Scope of Work – Arctic Bay Sewage Lagoon

The following is meant to describe, in as best of detail as time would permit (1 hour preparation time), the scope of works to be undertaken in the urgent repairs to the Arctic Bay Sewage Lagoon system.

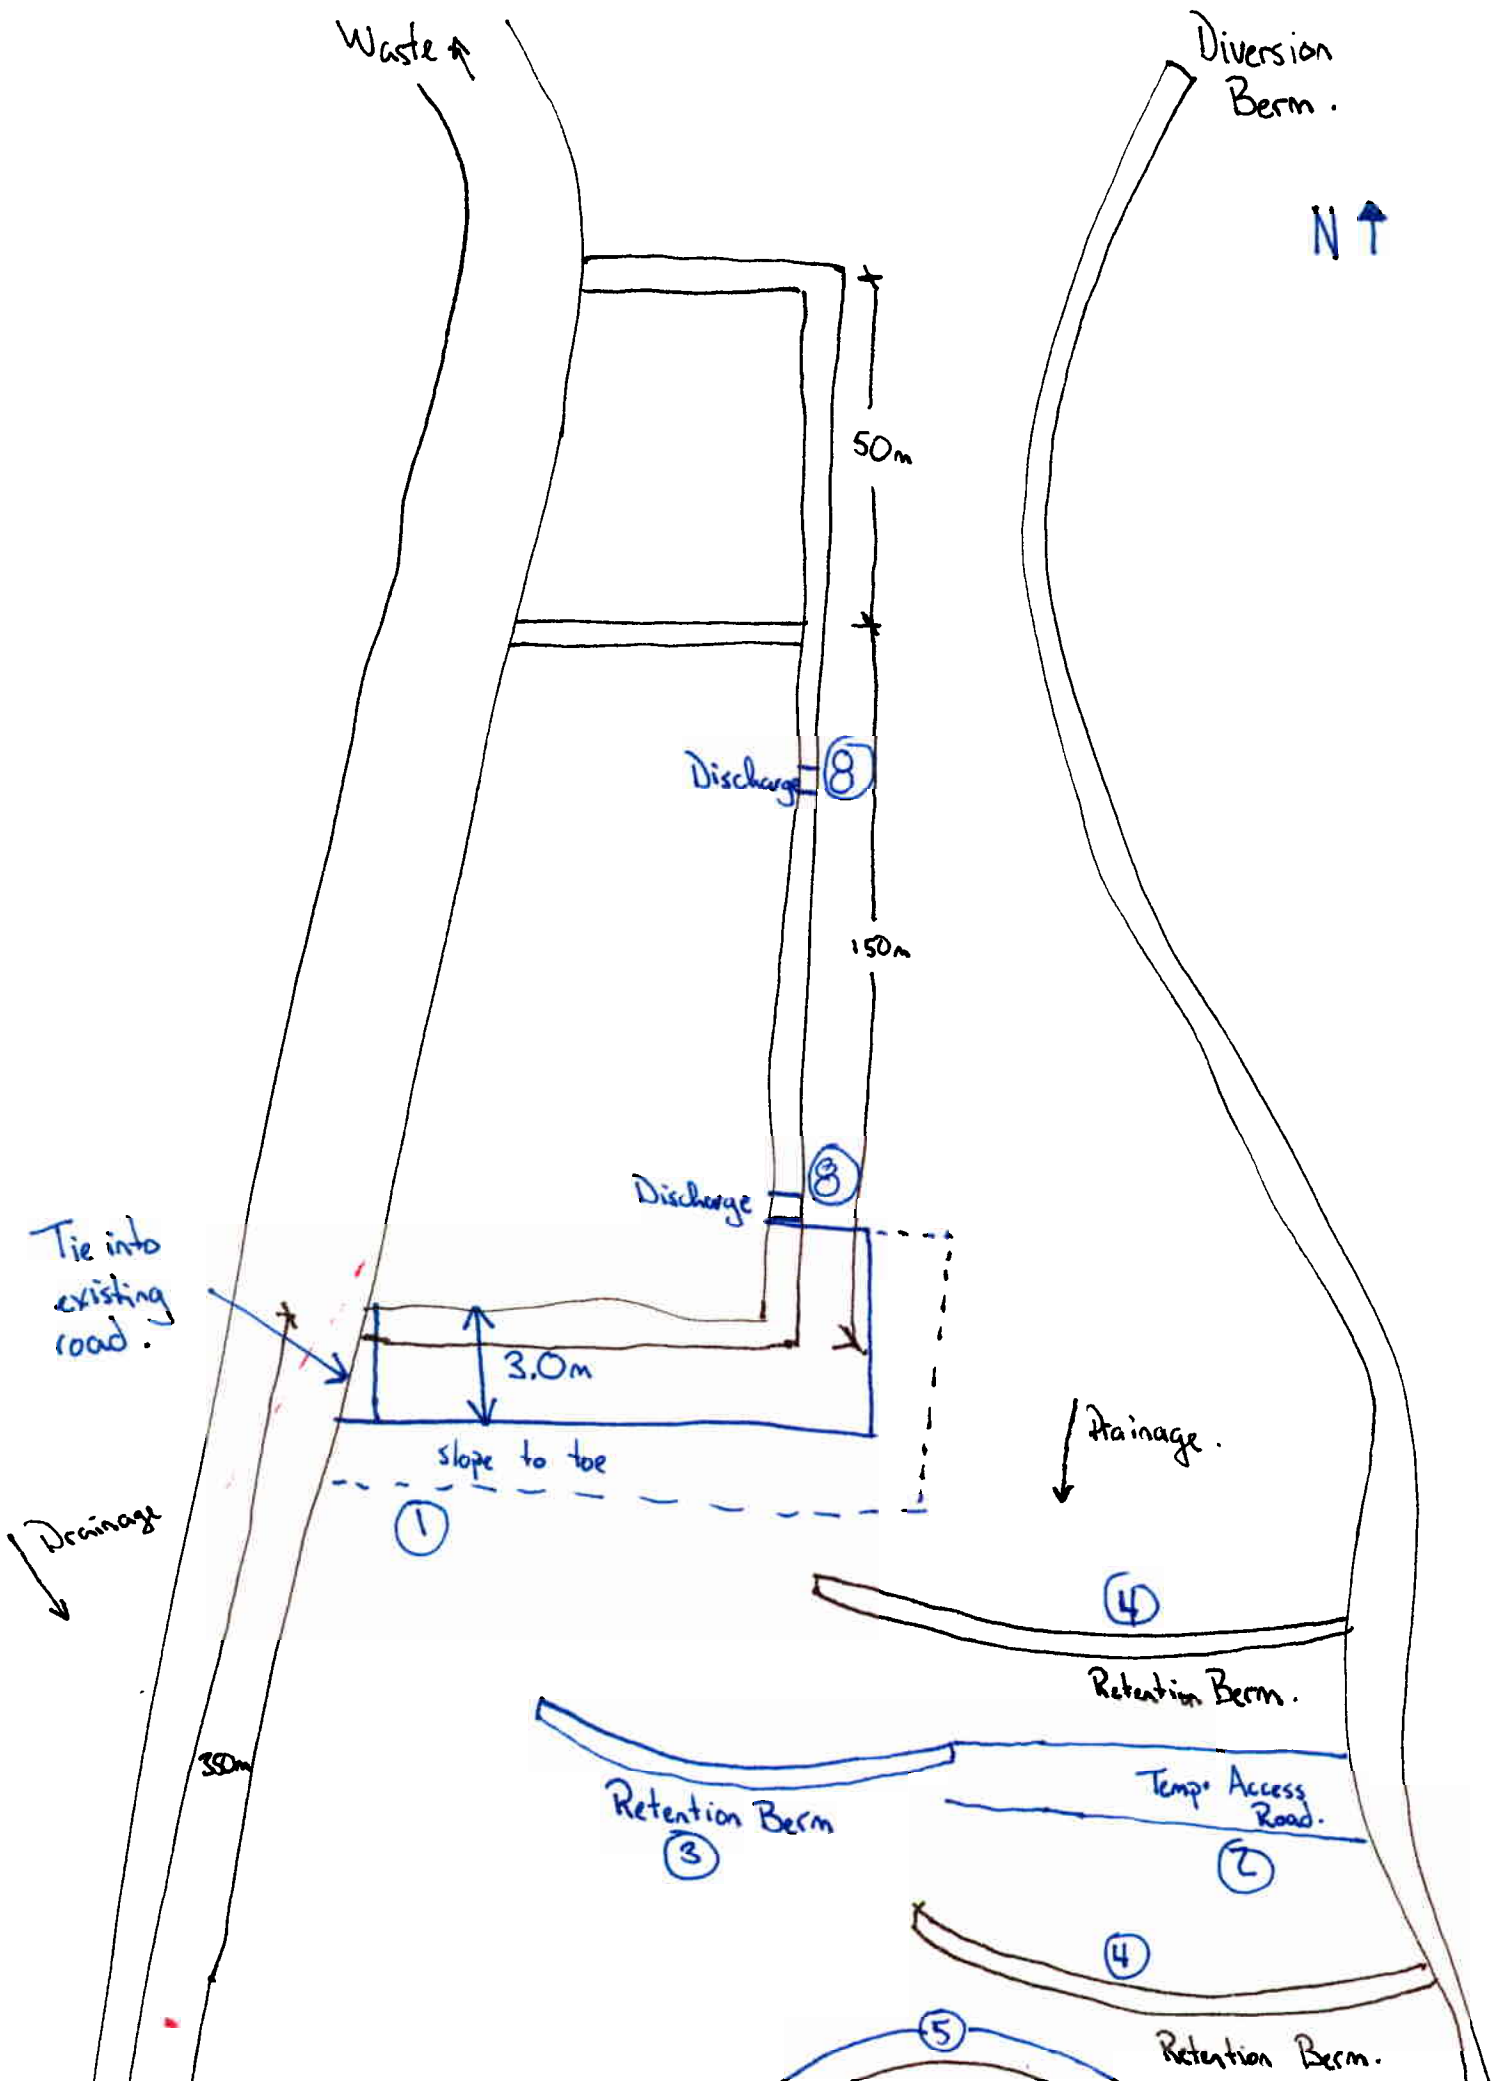
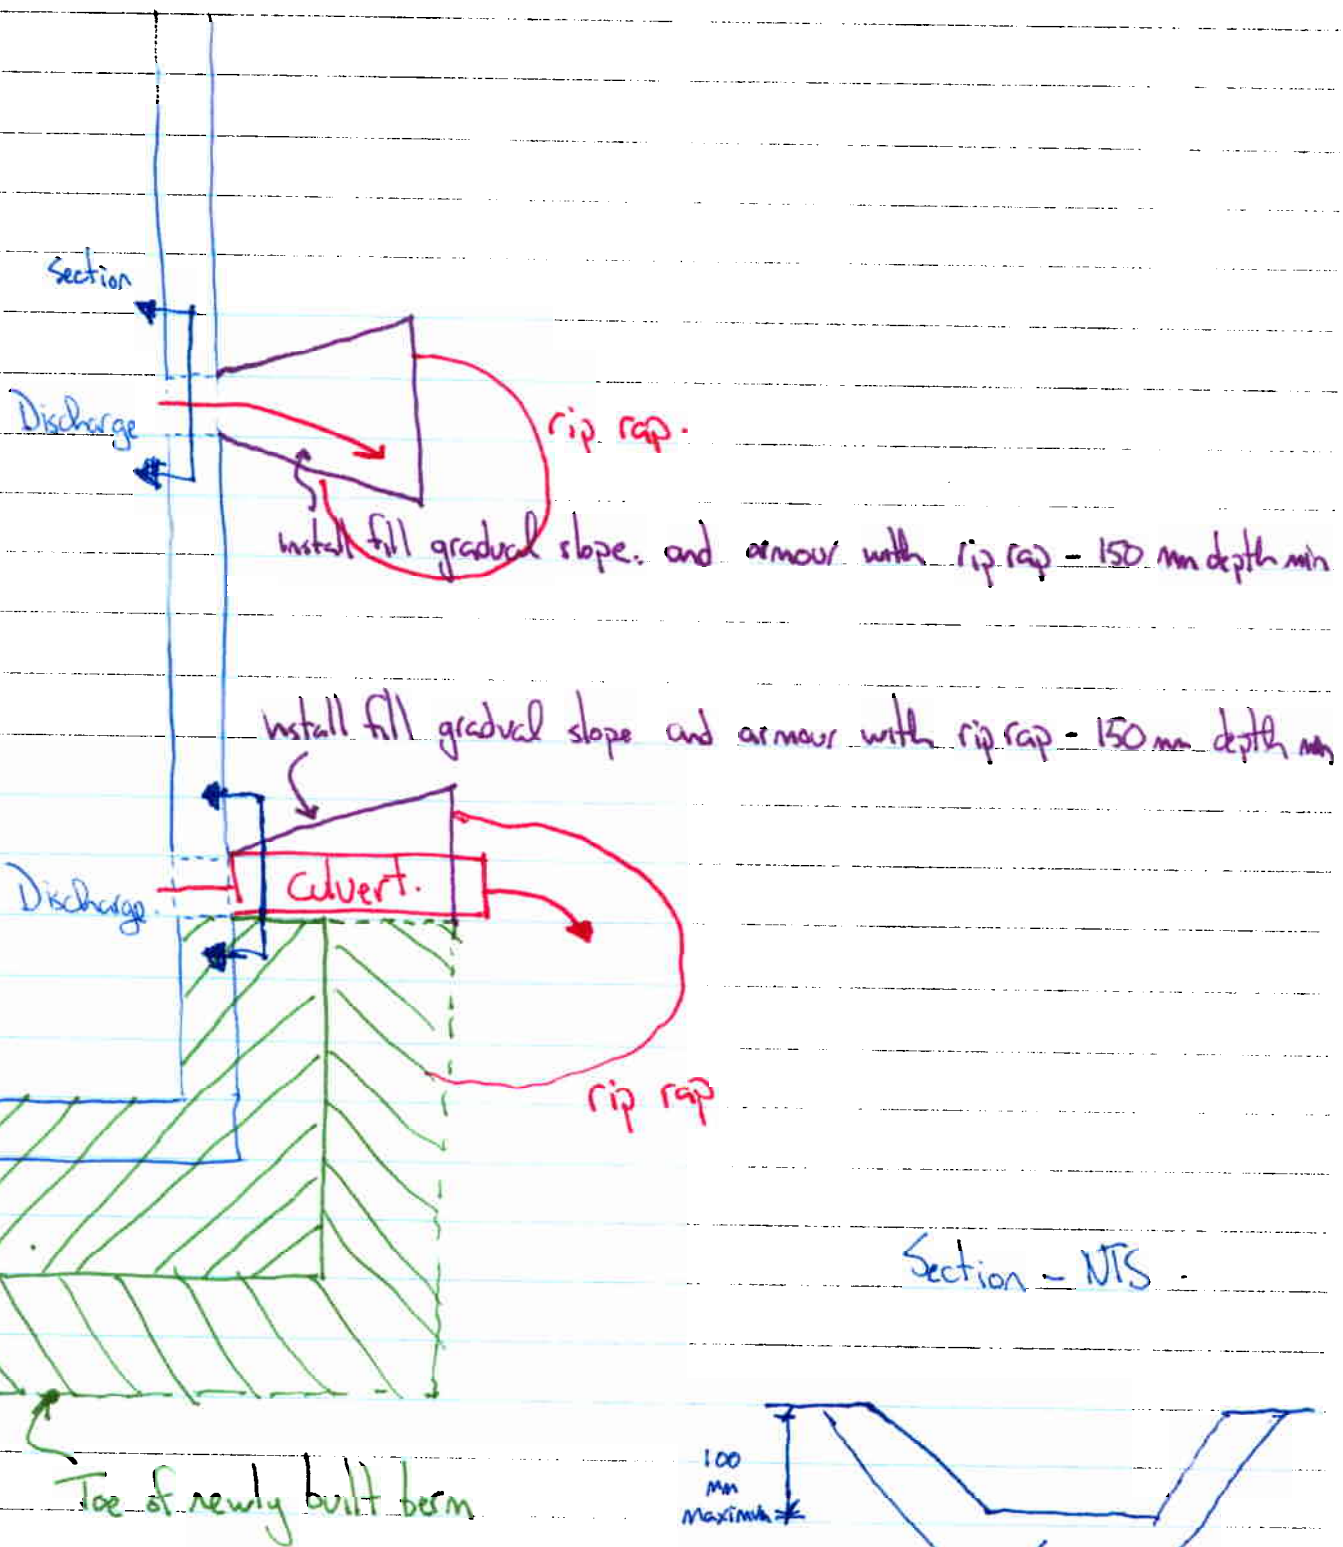
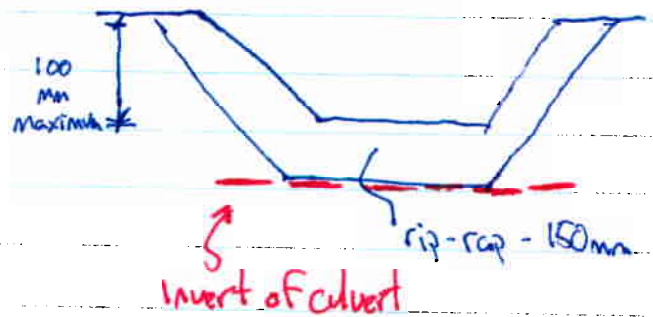
1. Reinforce/Expand South Berm of Winter Storage Cell

The berm of the winter storage cell shall be built up such that the top of the berm has a 3.0 m width (ie sufficient for a pick-up truck to travel on top of). The height of the berm shall remain as is currently build. The slope of the berm shall be the natural slope, approximately 2:1. The berm width shall be expanded from the southwest corner to the first discharge point.

2. Construct Temporary “Access Road” for Construction of Retention Berm

3. Construct Retention Berm

Addendum 1 - Step 8.

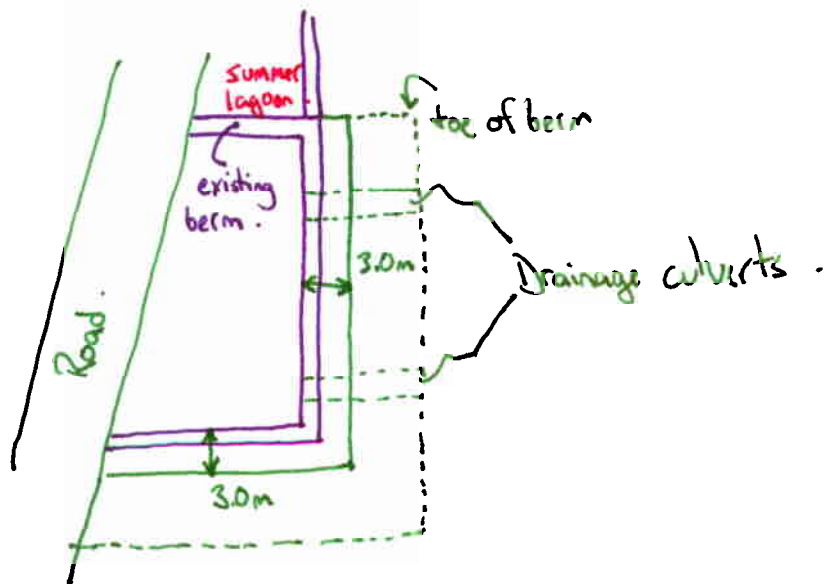
- ① At the northern most outflow of winter storage lagoon, construct gravel pad and rip-rap, add culvert, reduce height of berm at this location to encourage drainage from winter lagoon.
- ② ~~If~~ Add "gate valves" to culverts manually controlled from top of berm so as to be able to stop flow through culvert as required.
- ③ Continue building up full length of berm so that top of berm entire length of winter storage lagoon is 3 m width.

After Step 8, the winter lagoon should look like.
